Final Environmental Impact Report

Chapter 7 – Response to Comments

JASMINE SOLAR PROJECT

**Re: Response to Comments for Draft Environmental Impact Report – Jasmine Solar Facility Project
by SF Jasmine, LLC (PP22401) (SCH#2022060193)**

**Figure 3-12: Lakeview
Substation General
Arrangement**

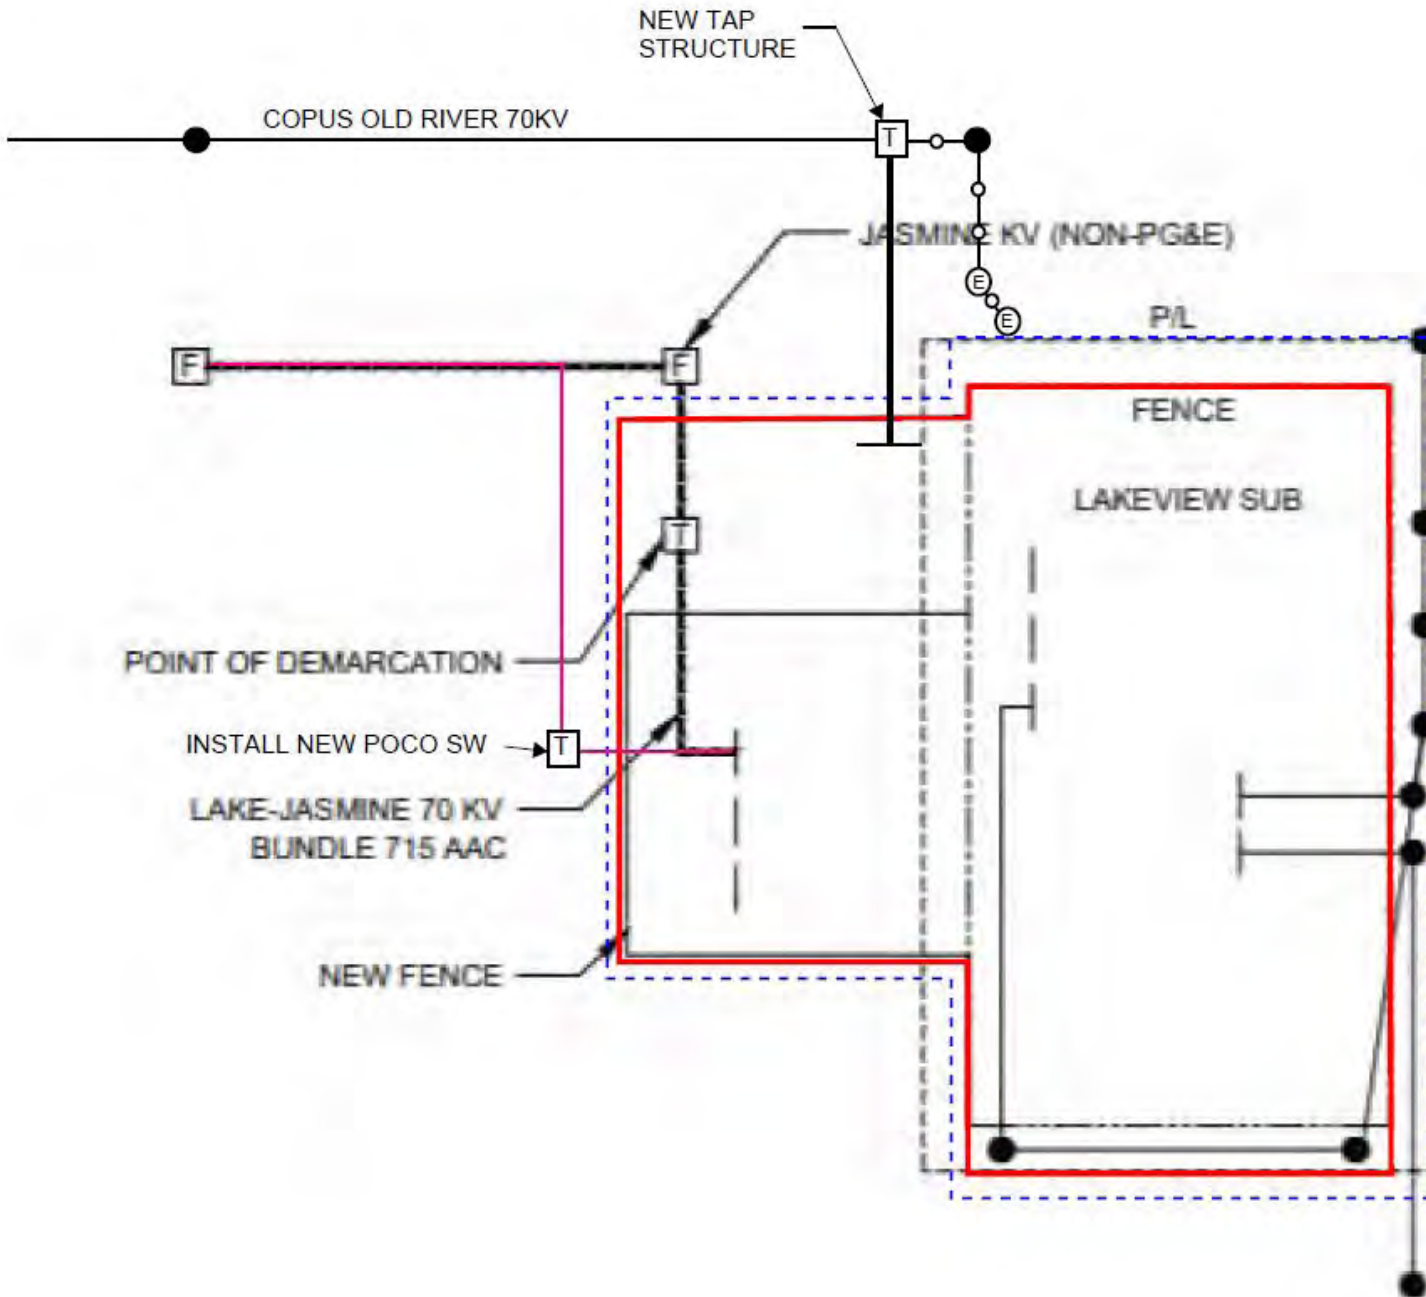
The existing Lakeview Substation, operated by PG&E, would require modifications that would occupy approximately 0.9 acres adjacent to the ~~western~~ eastern side of its existing footprint. The modifications are needed to accommodate improvements for the gen-tie line connection to the existing electrical equipment. Additional electrical equipment, including Direct Transfer Trip (DTT) equipment, Supervisory Control Data Acquisition and telemetry equipment, and breaker and control switching equipment, would be placed within the existing fenced area at the Lakeview Substation. Further discussion of the Lakeview Substation connections and modifications are included below in Section 4.7.5.

Figure 3-12: *Lakeview Substation General Arrangement*, would be revised, see following page.

The existing Lakeview Substation, operated by PG&E, would require modifications that would occupy approximately 0.9 acres adjacent to the ~~western~~ eastern side of its existing footprint. The modifications are needed to accommodate improvements for the gen-tie line connection to the existing electrical equipment. Additional electrical equipment, including Direct Transfer Trip (DTT) equipment, Supervisory Control Data Acquisition and telemetry equipment, and breaker and control switching equipment, would be placed within the existing fenced area at the Lakeview Substation. Further discussion of the Lakeview Substation connections and modifications are included below in Section 4.7.5.

**Figure 3-12: Lakeview
Substation General
Arrangement**

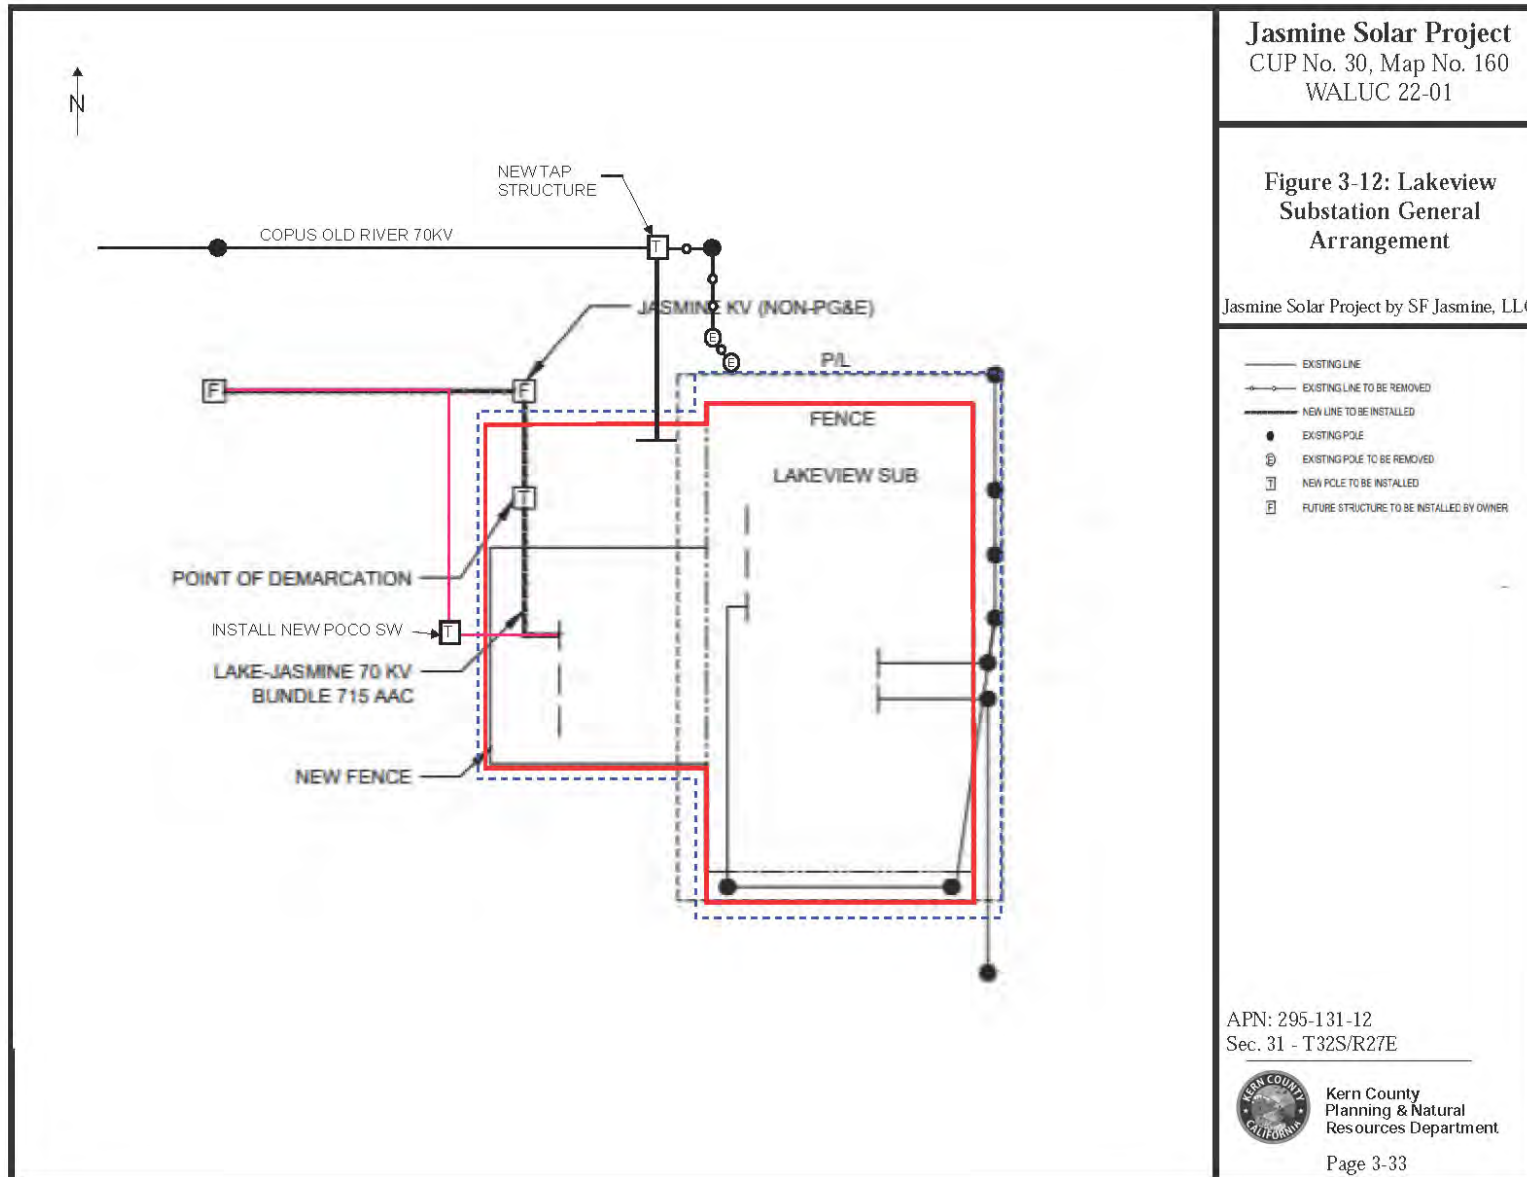
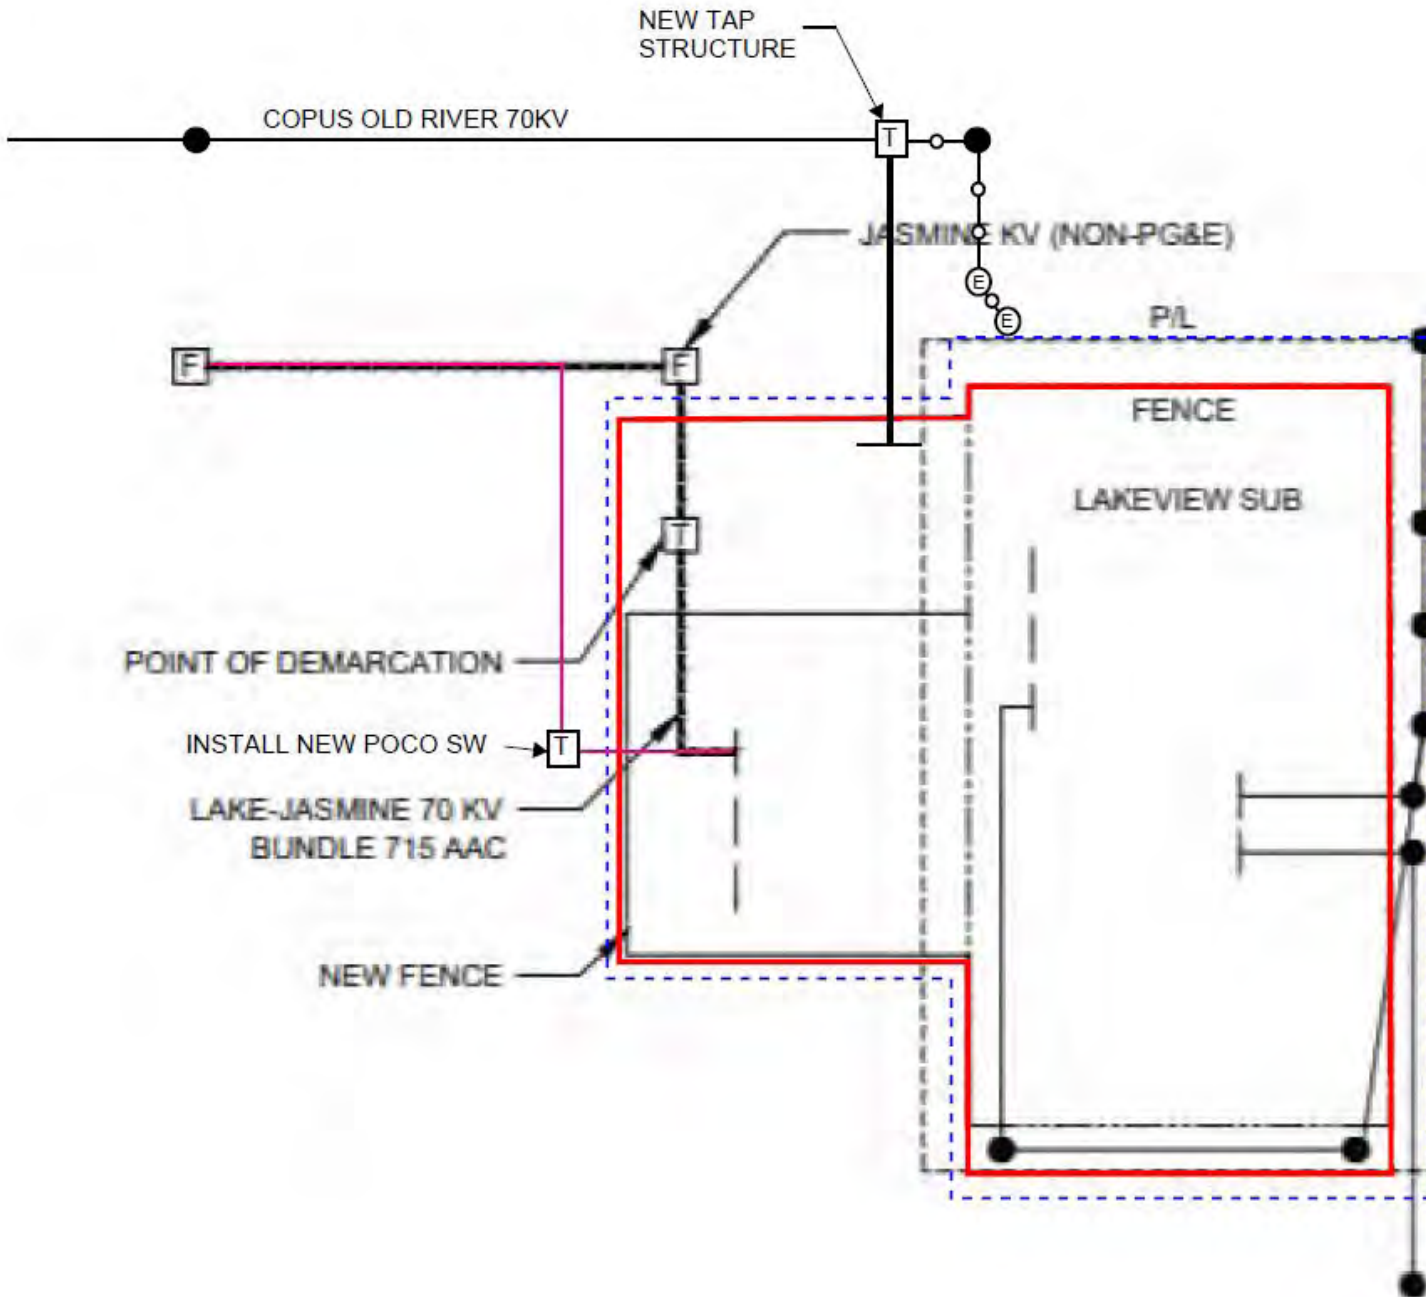
Because the CPUC will rely on the EIR, PG&E requests that minor changes be made to accurately describe PG&E’s current project plans. First, the substation will be expanded to the west rather than the east, as indicated in two locations. **Please replace “eastern” with “western” at pp. 1-9, 3-24.** Also, **all of the power line work described above should be included at page 3-35,** as the description is currently incomplete. Finally, the substation expansion and power line details provided in the DEIR in Figure 3-12, page 3-33, are not accurate based on PG&E’s current engineering design. **Please replace Figure 3-12 with the updated figure PG&E has enclosed,** which is a redline version of Figure 3-12 showing the current plans for the substation expansion and power line interconnection facilities. PG&E notes that these minor revisions will not change the impact conclusions in the DEIR.

Additionally, the commenter states that the substation expansion and power line details provided in **Figure 3-12: Lakeview Substation General Arrangement**, are inaccurate, based on the current design. A redline, revised figure has been provided by the commenter and as such **Figure 3-12: Lakeview Substation General Arrangement** on Page 3-33 in Chapter 3, *Project Description* in the Draft EIR has been revised as shown below.

PG&E’s upgrades will include a 0.9-acre westerly expansion of PG&E’s Lakeview Substation and a new 150-foot 70 kV power line with a new approximately 80- to 95-foot-tall tubular steel pole (TSP) to accommodate the customer’s generation-tie line interconnection. The typical design of the structures is provided in **Figure 3-14: Typical Tubular Steel Design.**
